# SITE PLAN FOR PROPOSED STORAGE UNIT DEVELOPMENT PARCEL NO-06-26-301-034 HOWELL TOWNSHIP, MI

**Site Plan Review  
For  
Howell Township, Michigan**

<b>Applicant:</b>	Tom Schroeder
<b>Project Name:</b>	Cornerstone Group
<b>Plan Date:</b>	June 20, 2024
<b>Location:</b>	East of W Highland Road (M-59) & North of I-96
<b>Zoning:</b>	Industrial (I)
<b>Action Requested:</b>	Preliminary Site Plan Approval

RE: Proposed Storage Unit Development (Transcontinental West)  
Parcel #06-26-301-034 Howell Township  
Preliminary Site Plan Review

DETAILS SHEET

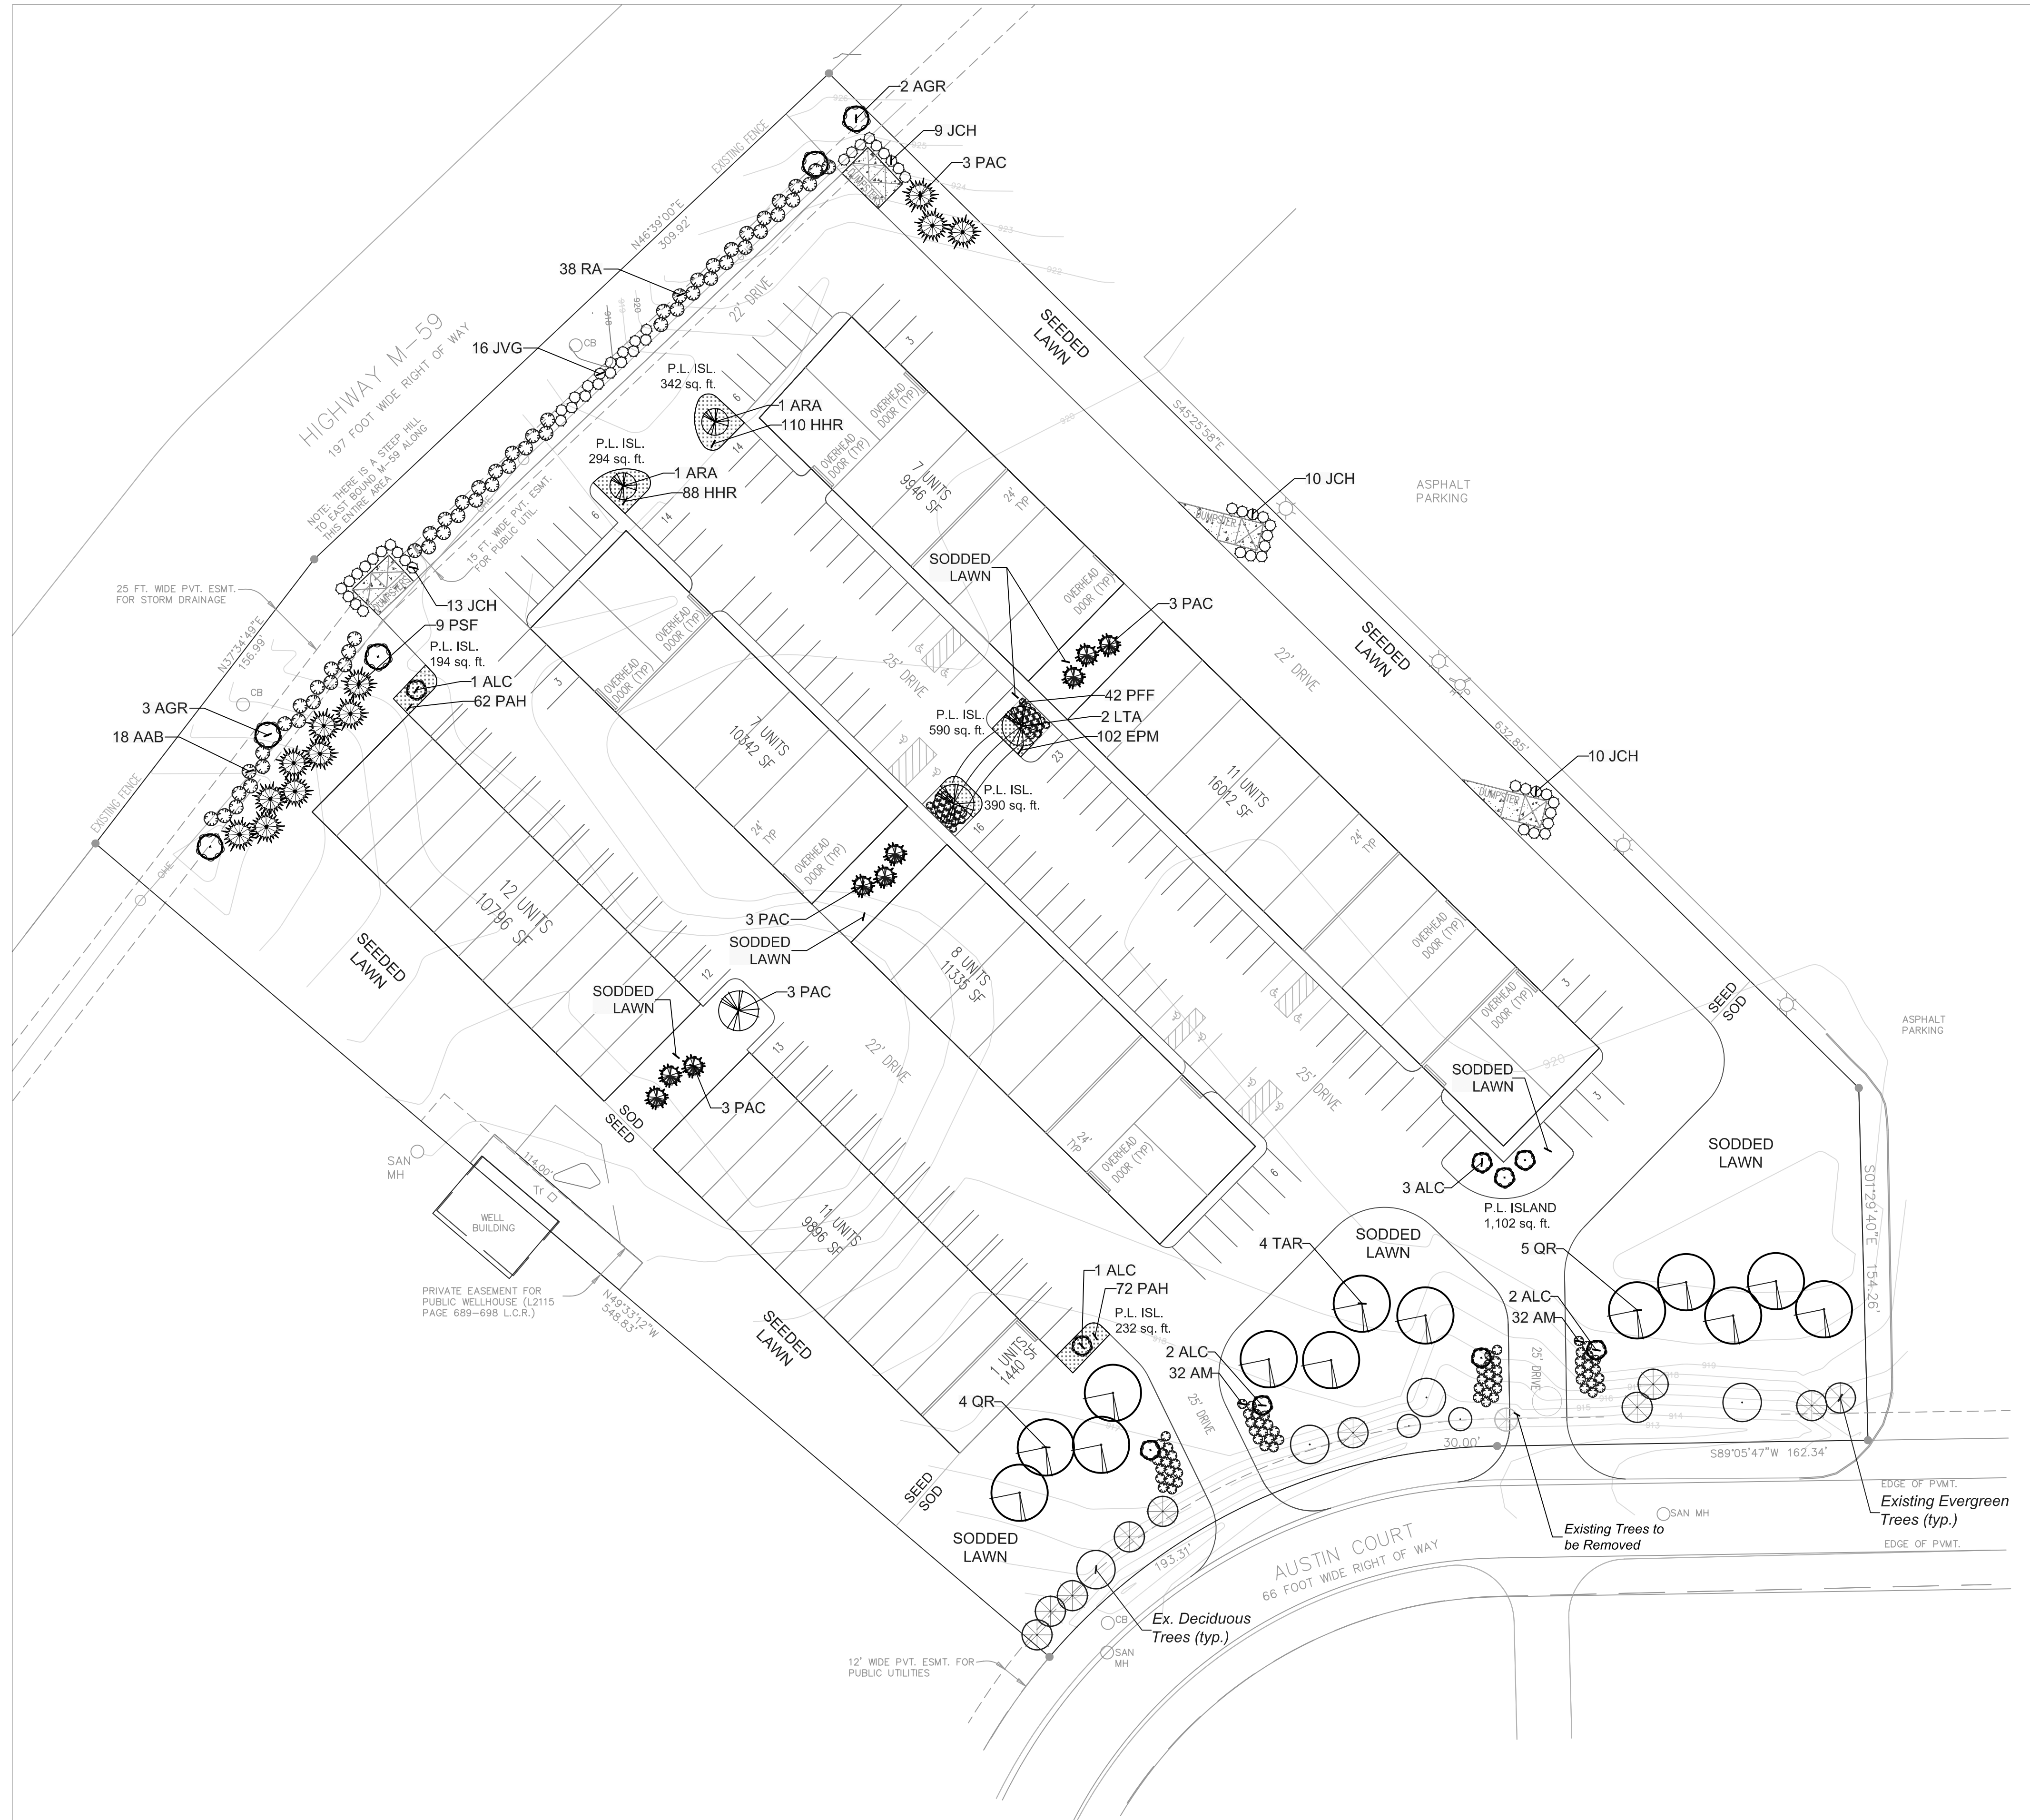
**Items to be Addressed:** 1) Provide trash enclosure details for the two (2) dumpsters along the eastern lot line. 2) Relocate trash receptacles along Eastern property line to avoid encroachment on the ten (10) foot side yard setback.
